REFERRAL REPORT

TO: Vancouver City Council
FROM: General Manager of Planning, Urban Design and Sustainability
SUBJECT: CD-1 Rezoning: 1402-1462 Burrard Street, 1401-1451 Hornby Street and 900 Pacific Street

Figure E-12: Views From Creekside Park (L), May & Lorne Brown Park (M), Burrard Bridge (R)

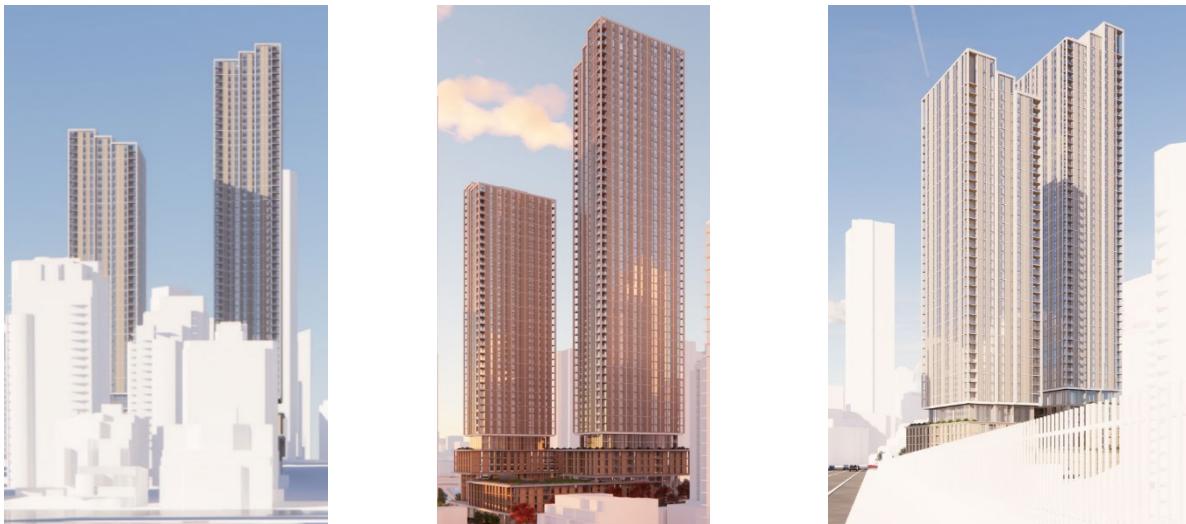
However, it is recognized that large towers can have adverse impacts on the surrounding public realm and access to natural light, air, and views. Furthermore, the elongated rectangular towers (81 ft. wide, 110 ft. / 120 ft. long) appear slender with appropriate openness to the sky

when viewed from the width (see Figure E-12, left), but look much bulkier when viewed from the length, presenting a heavier massing against the sky. This effect is most evident from Burrard Bridge and May & Lorne Brown Park (see Figure E-12, middle and right). Staff recommend further exploration to the tower scale and proportion to reduce the perceived massing and bulk, such as reducing the length, lightening the top, articulating the corner, or tapering the massing. Refer to condition 1.3 in Appendix B.

Figure E-13: Tower Separation and Placement

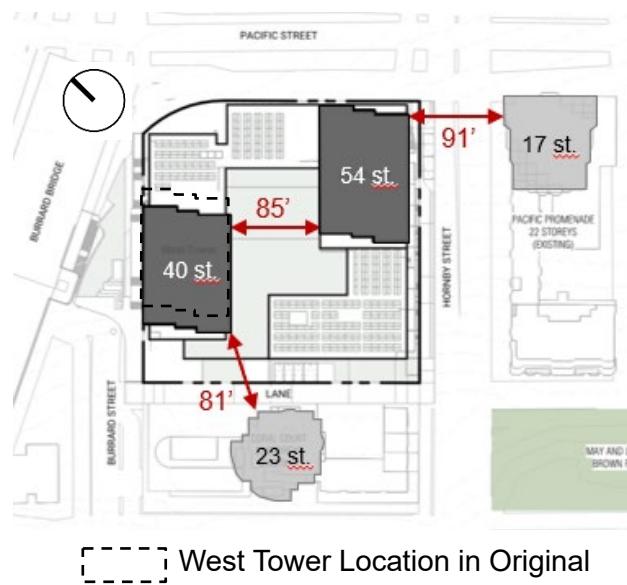
The minimum residential tower separation is 80 ft. The proposed towers are 85 ft. apart and are set back more than 80 ft. from adjacent existing towers (see Figure D-13). While the tower separation standard ensures a horizontal distance between towers, it does not account for the effect of towers' height and massing. The taller and larger the towers are, the greater their impacts on the surrounding public realm livability in terms of access to natural light, air, and views. Staff raised this concern during the review process, and the applicant revised the design by shifting the west tower southwest approximately 5 m (17 ft.) to reduce overlap with the east tower, slightly improving their spatial relationships. Staff recommend further design exploration, including additional massing shifts and articulation of the corners to enhance the space between the two towers. Refer to Condition 1.3 in Appendix B.

Figure E-14: Bridgehead Setback

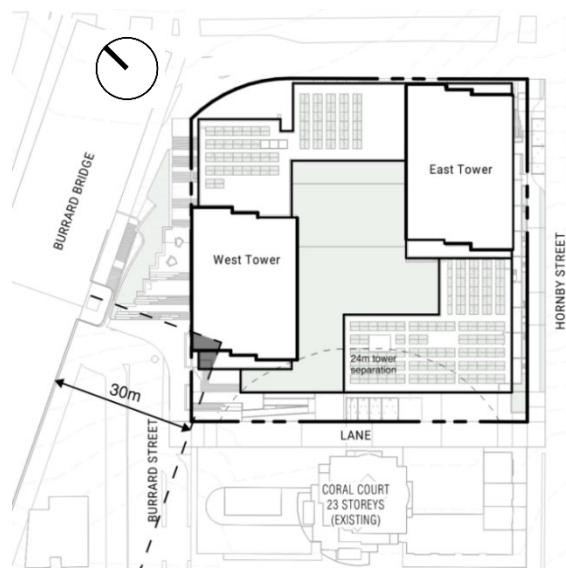
The Bridgehead Guidelines recommend building setbacks and heights to preserve public views and enhance the experience of crossing the bridge. The application encroaches on the 30 m setback at the west corner, as shown in grey in Figure E-14. Staff have assessed the impacts and concluded that this modest encroachment will not compromise the bridgehead experience. In contrast, staff would consider additional flexibility in the setback requirements to allow the tower massing to shift southwest, thereby widening the bridgehead view.

Figure E-15: Site Plan and Landscape Design

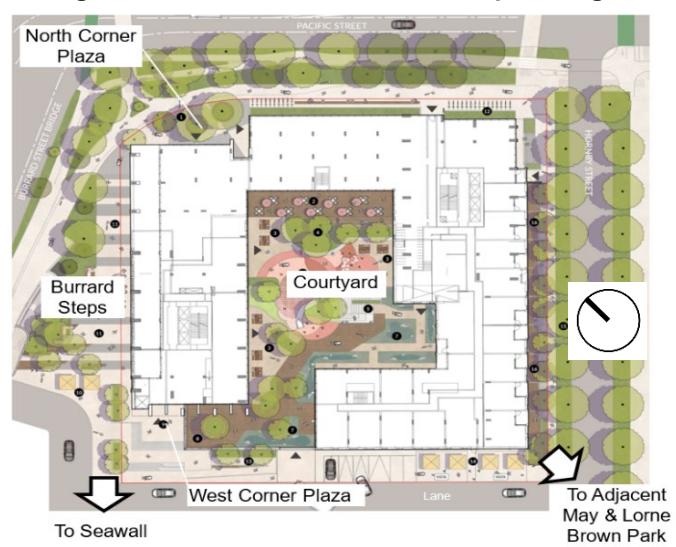
The application proposes public open spaces at the north and west corners and incorporates residual city space between the bridge and this development (Burrard Steps) to create a more legible pedestrian connection to the Seawall (see Figure E-15). The design of these spaces is challenged by the sloping topography and the adjacent bridge structure. During the review process, staff raised the concerns about accessibility and activation. The applicant responded by adding a public arcade at street level with an elevator connecting to the lane. Further design efforts are expected at Development Permit application stage to unify these public open spaces and ensure they are inviting, engaging, and accessible for public use. Refer to Condition 1.4.a) in Appendix B.

In addition, the application proposes commercial uses on Pacific Street, ground-oriented residential units on Hornby Street, and service functions along the lane. Further design improvements are required to strengthen pedestrian-oriented public realm along all frontages. Staff also recommend exploring an open space at the south corner to enhance the relationship with May & Lorne Brown Park and the walkable public realm network, which is considered a key component in integrating this development into the local context. Refer to Condition 1.4 in Appendix B.
